2021 PSE Integrated Resource Plan

Appendix A

Public Participation

This appendix describes public involvement in the development of the 2021 PSE IRP.

Temperature Sensitivities, planning standard and recent peak load data

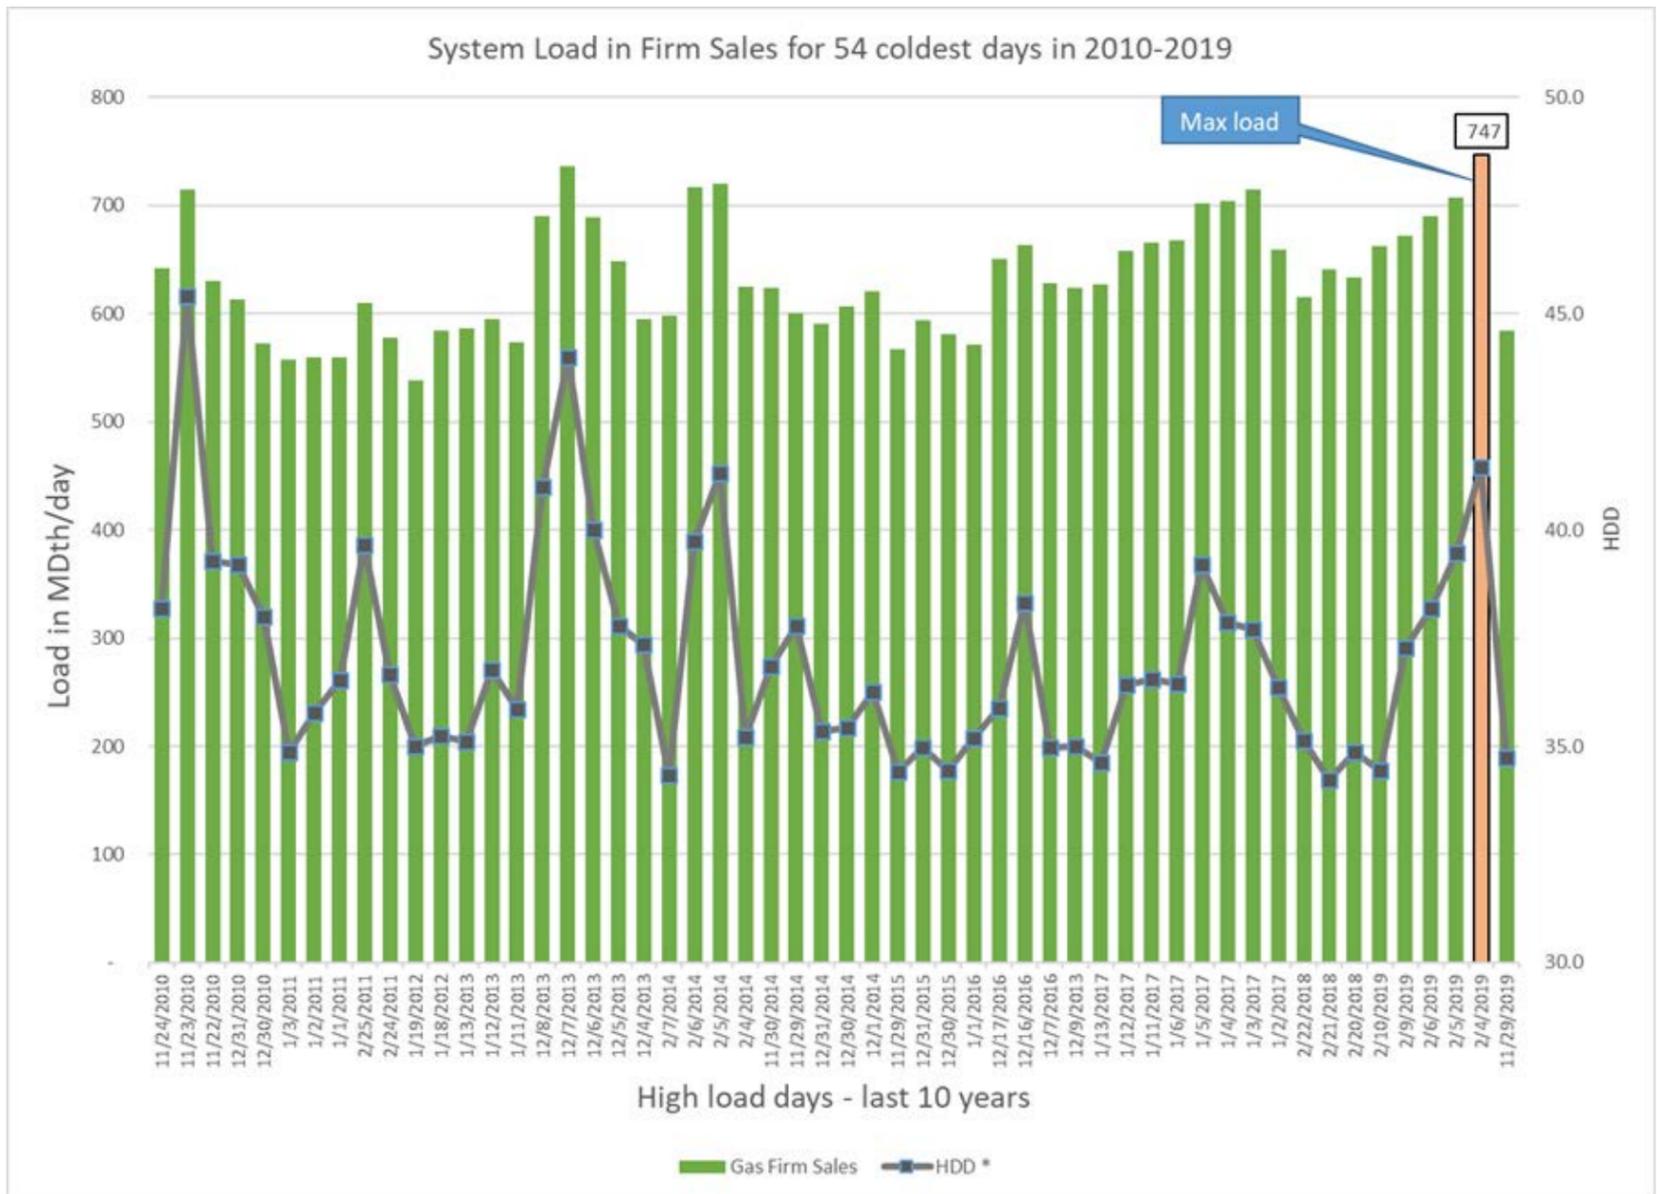
PSE received a request to share the most recent 10 years of peak day load experienced by the gas system. The graph below includes the highest load days over the last 10 years along with the gas system load and associated HDD.

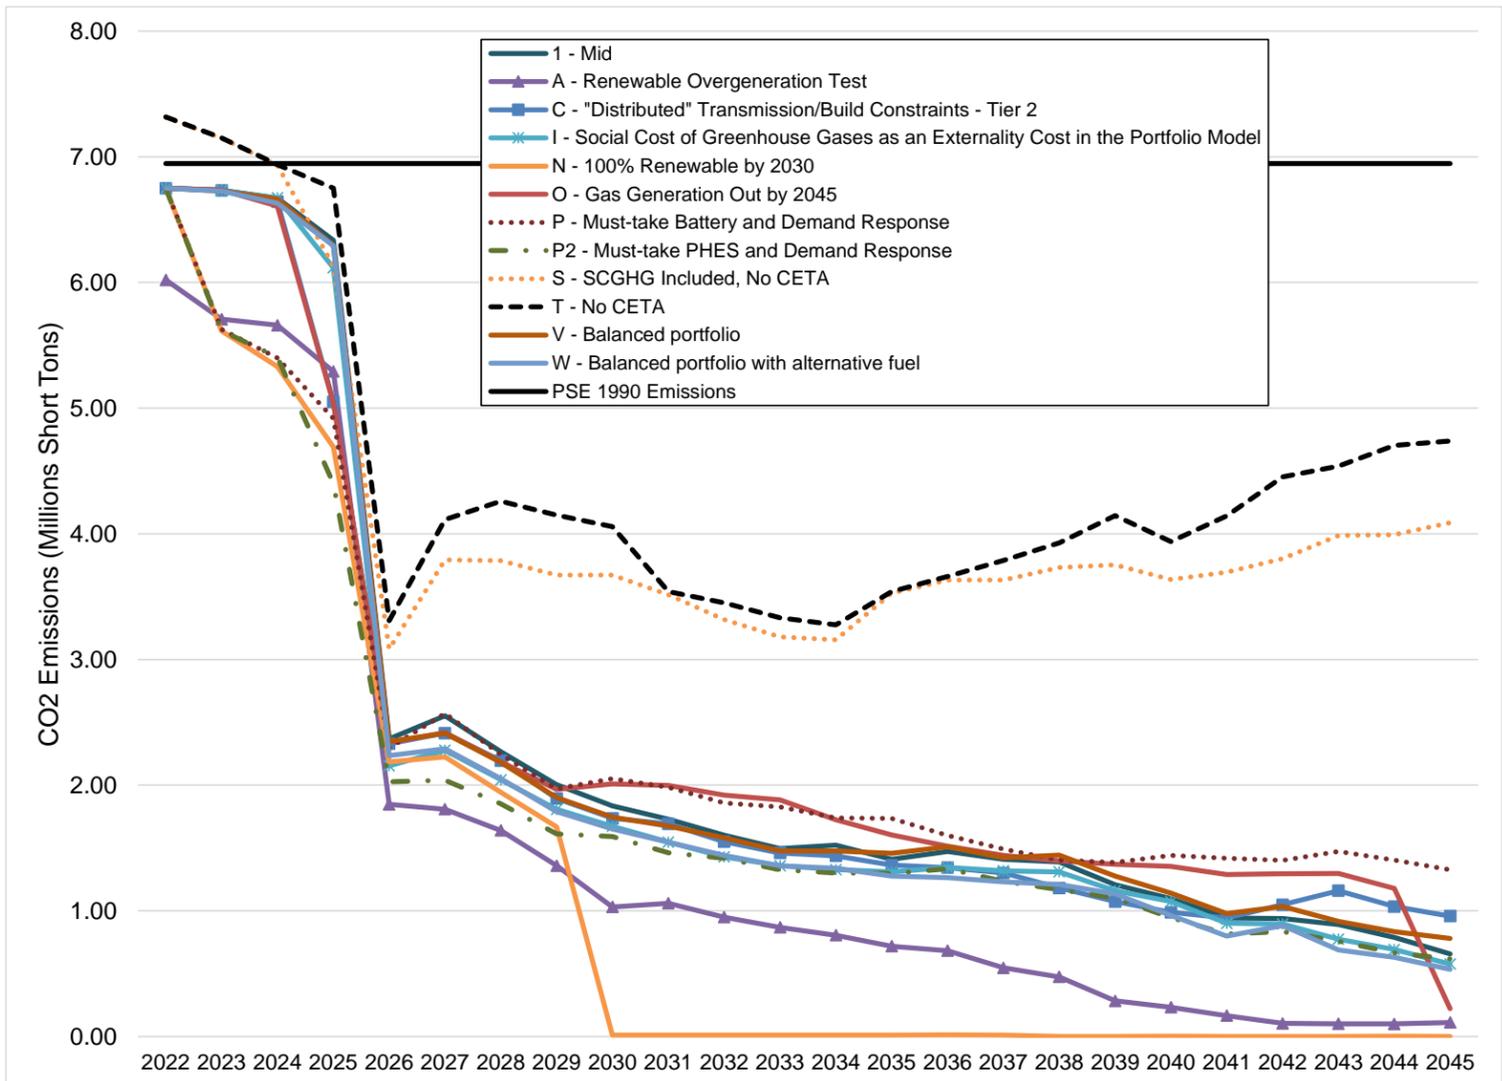
1. Willard Westre (Union of Concerned Scientists) asked for clarification on the emissions chart on Slide 17. In the Feedback Report, PSE released a revised version of the chart which addresses Willard’s questions. PSE would note that the reduction in greenhouse gas emissions from 2019 to 2029 is 75%.
